TRAFFIC MONITORING SITE

ORIGINATION FORM

Proposed Revisions to a Standard Plans Index
(Please provide all information — Incomplete forms will be returned)

Index Number: 695-001
Sheet Number (s): 1 through 7
Index Title: Traffic Monitoring Sites

LANE CONFIGURATION FOR TMS INDUCTIVE LOOP AND STRAIN GAUGE/QUARTZ AXLE SENSOR

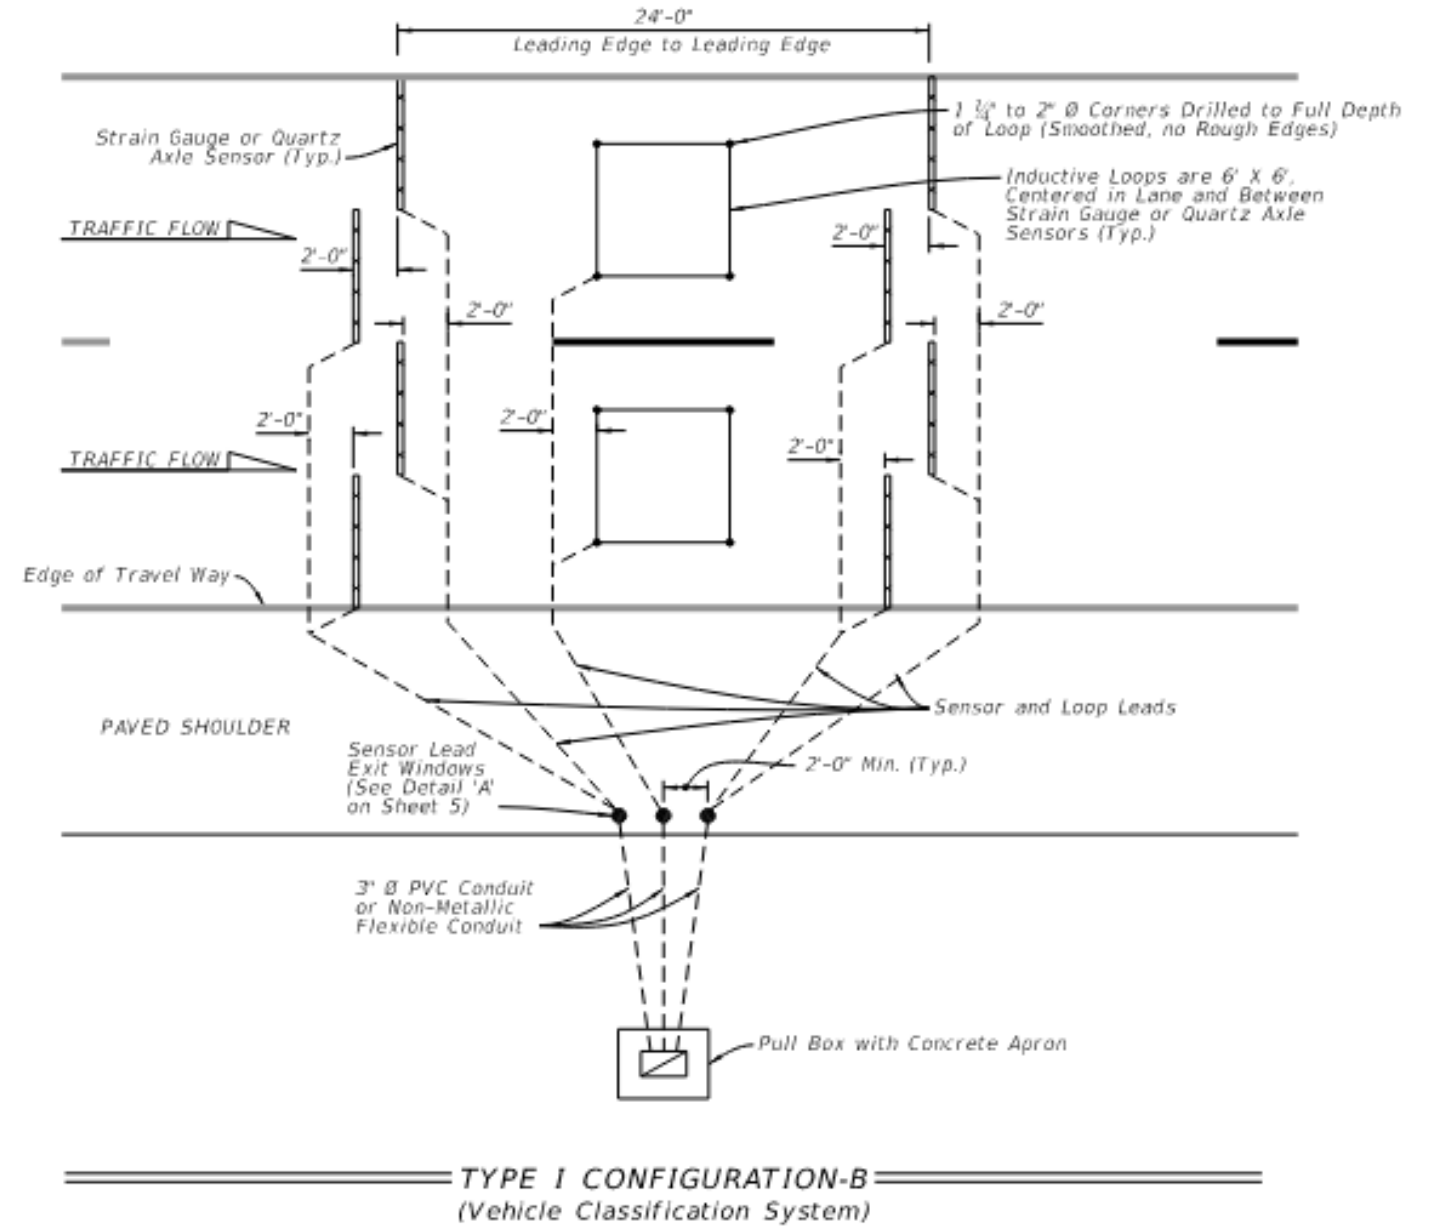
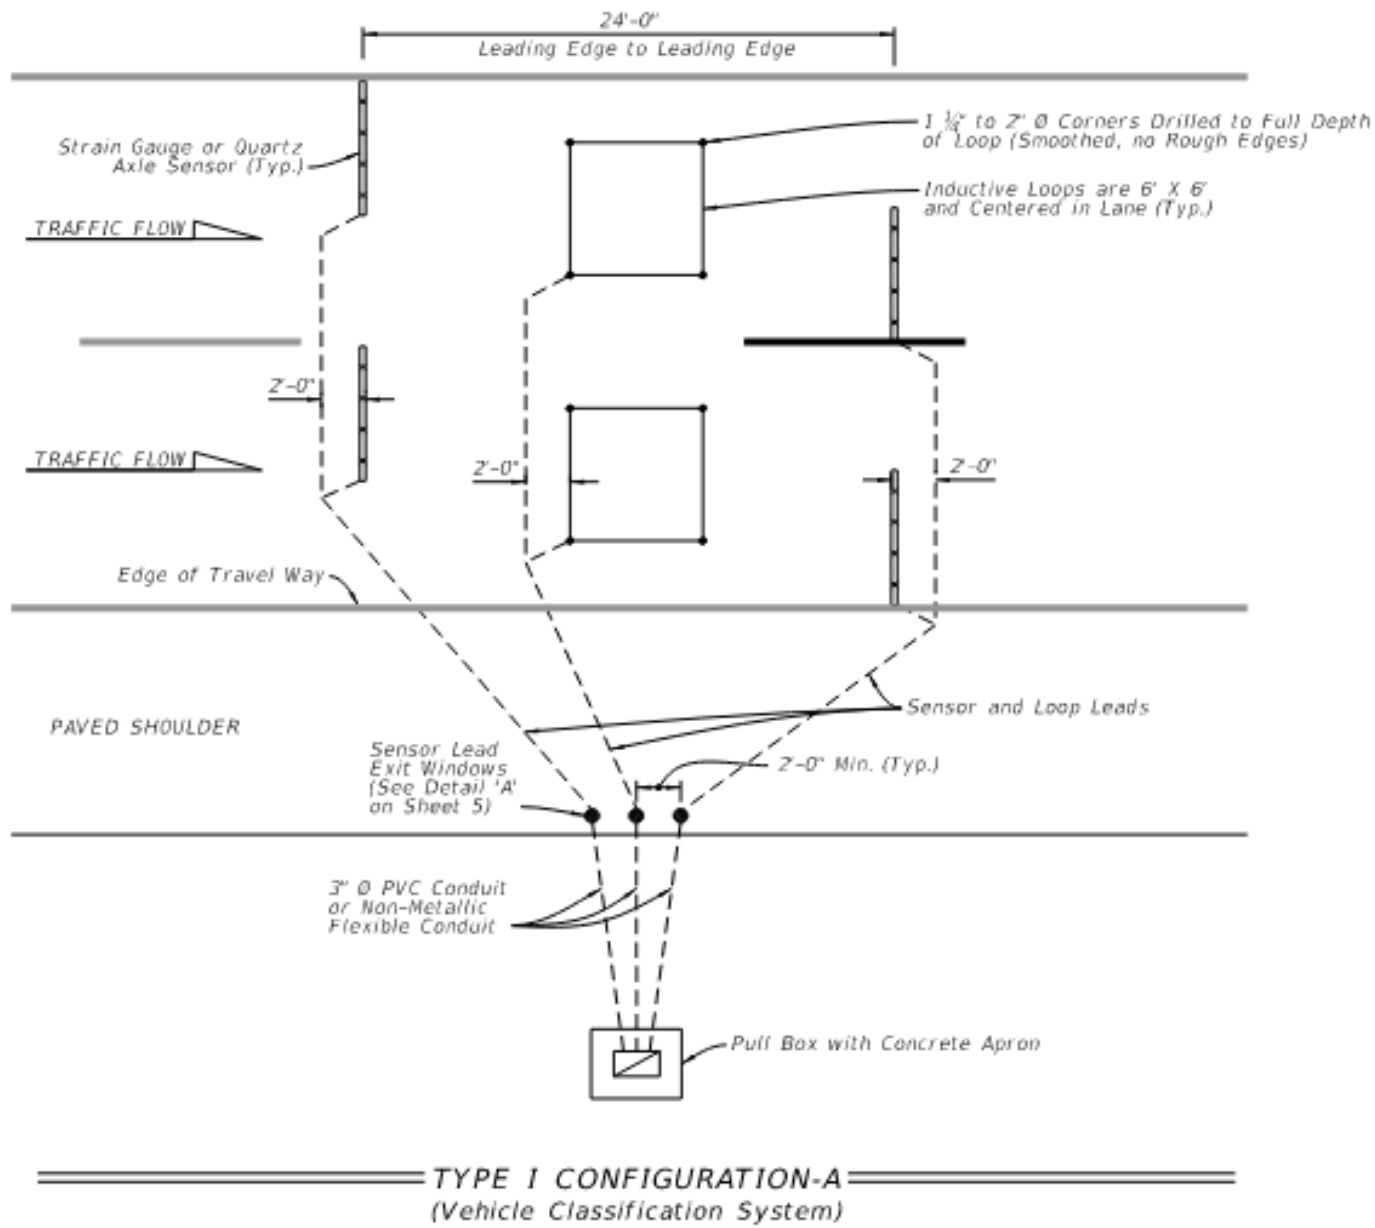
ADDED NEW DETAILS

LANE CONFIGURATION FOR MAINLINE INDUCTIVE LOOP AND QUARTZ AXLE SENSOR

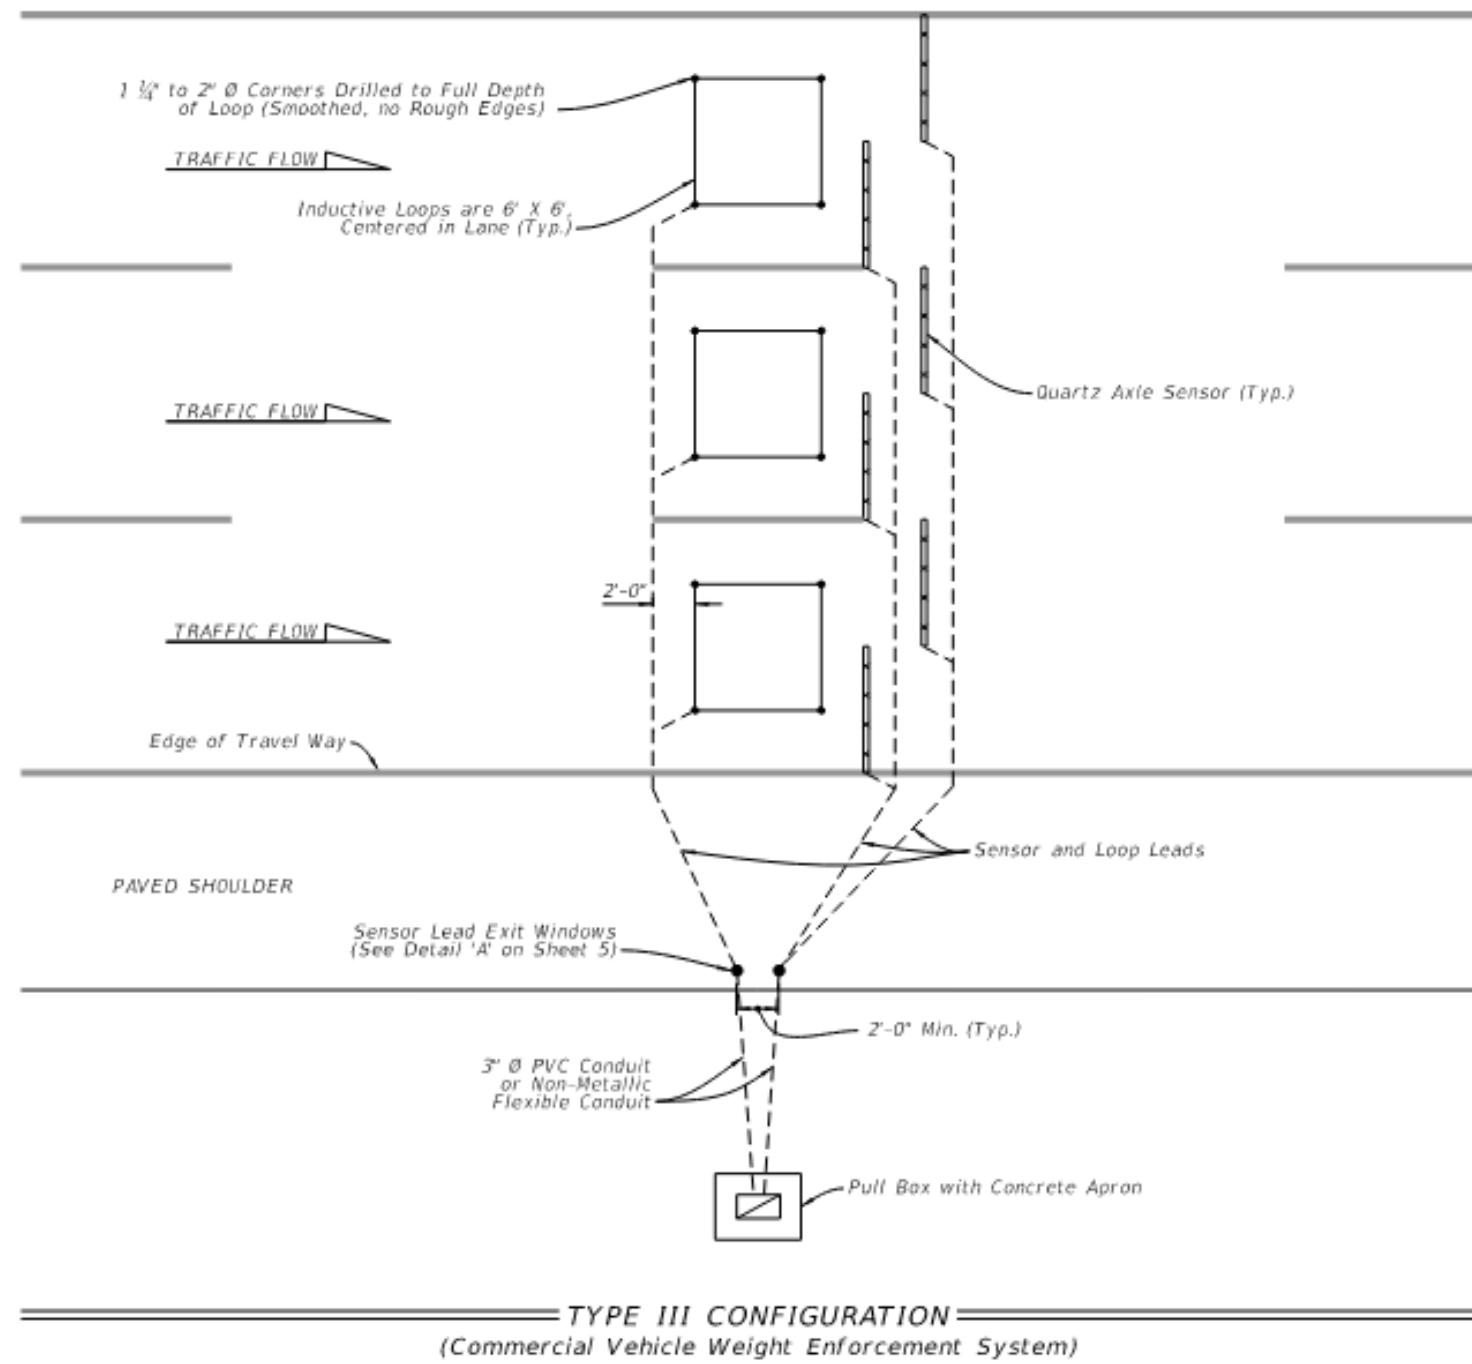
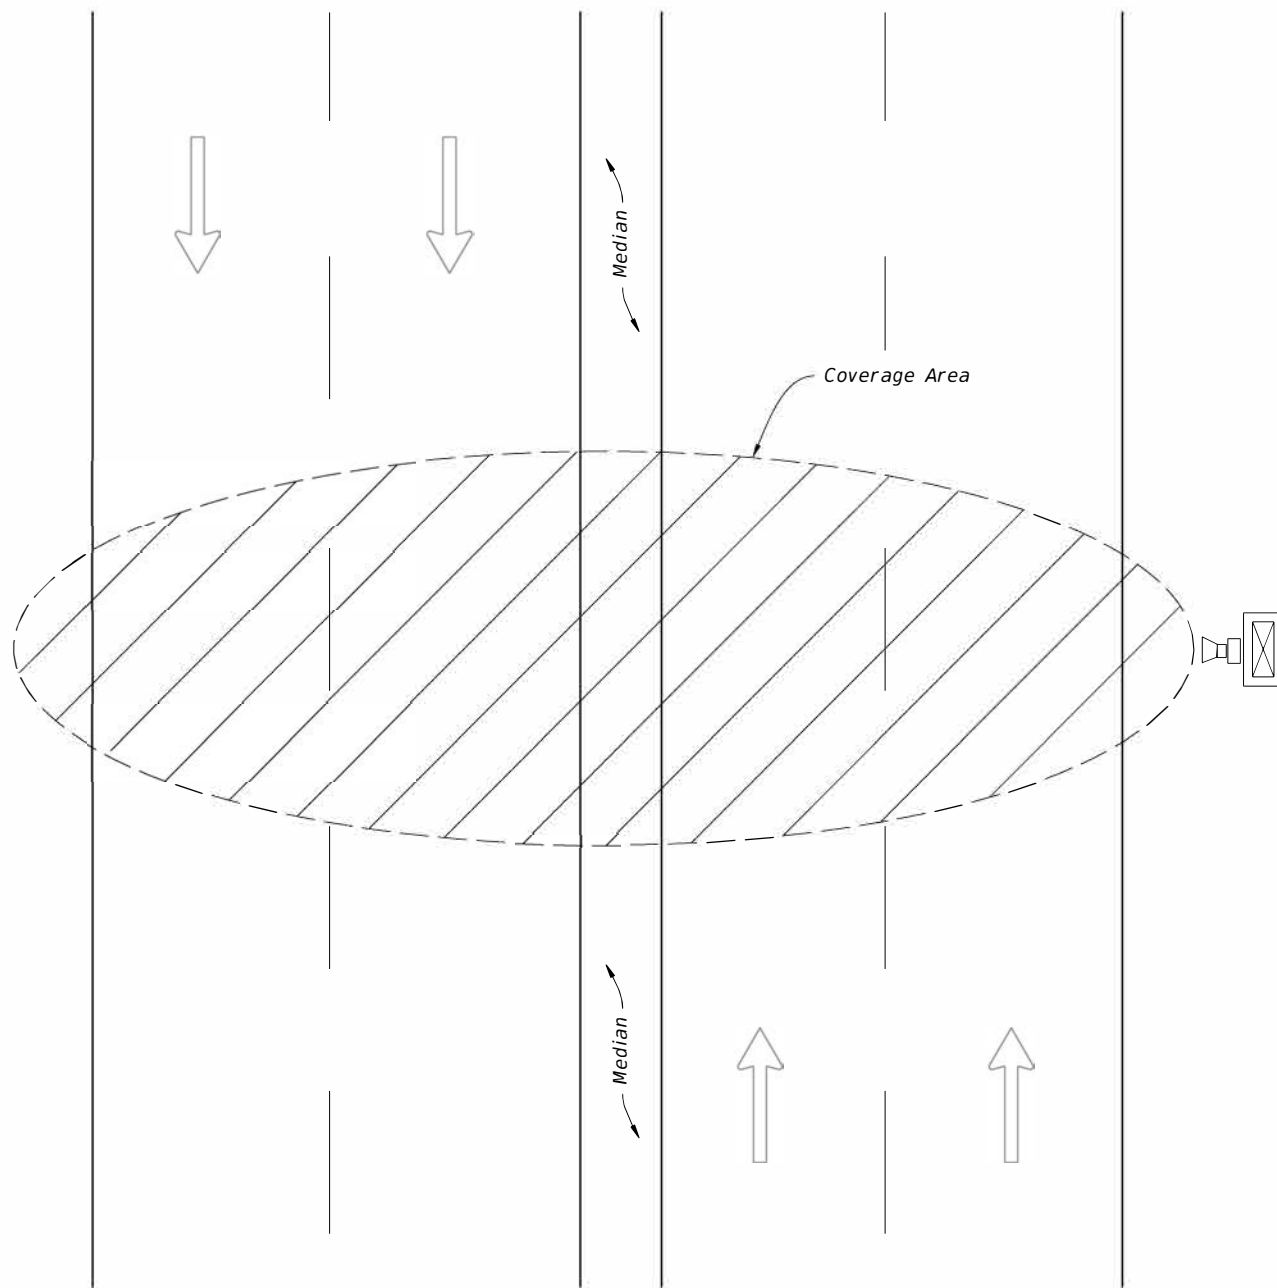
ADDED NEW DETAILS

SOLAR POWER POLE WITH POLE MOUNTED CABINET (Telemeter Sites)

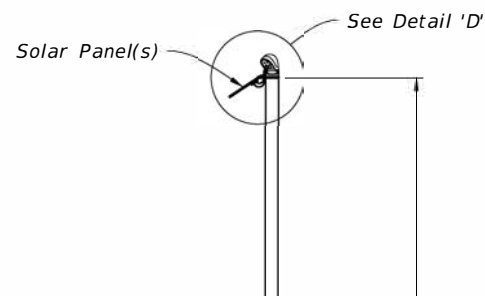
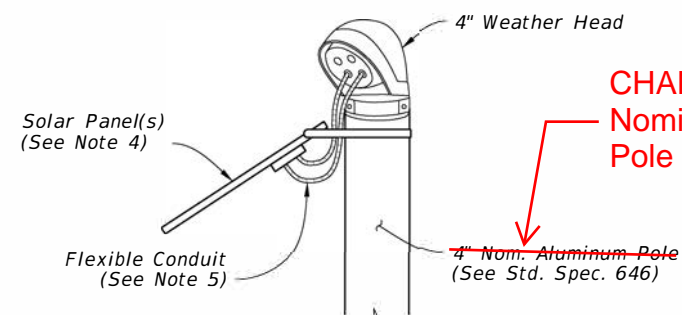
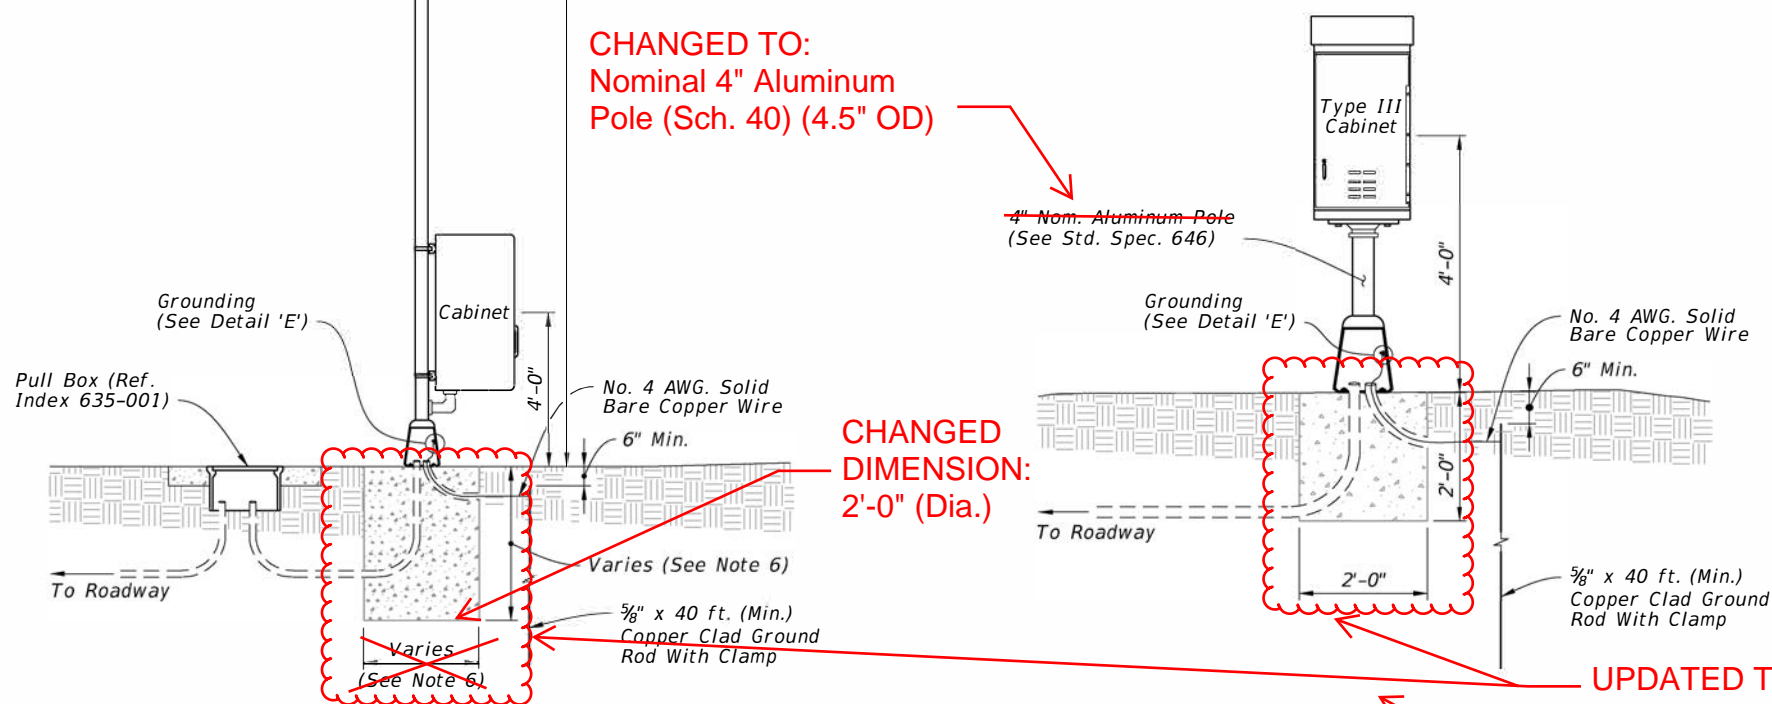
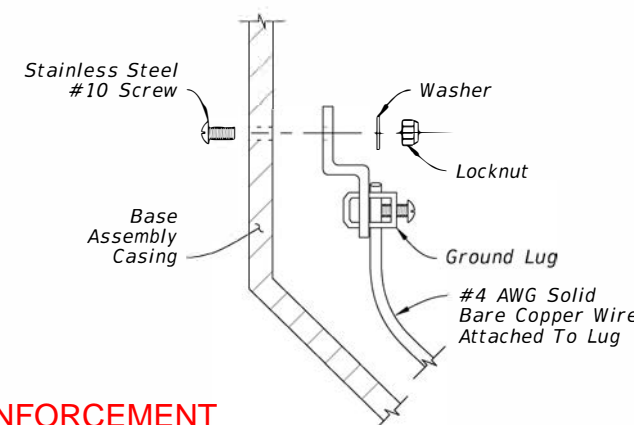
UPDATED NOTE 2: Meet the material requirements of Specification 646.

CHANGED TO:
Nominal 4" Aluminum Pole (Sch. 40) (4.5" OD)

UPDATED NOTE 6b and 6c.

CHANGED TO: Dimensions

CHANGED TO:
Nominal 4" Aluminum Pole (Sch. 40) (4.5" OD)

CHANGED TO:
Nominal 4" Aluminum Pole (Sch. 40) (4.5" OD)

CHANGED DIMENSION:
2'-0" (Dia.)
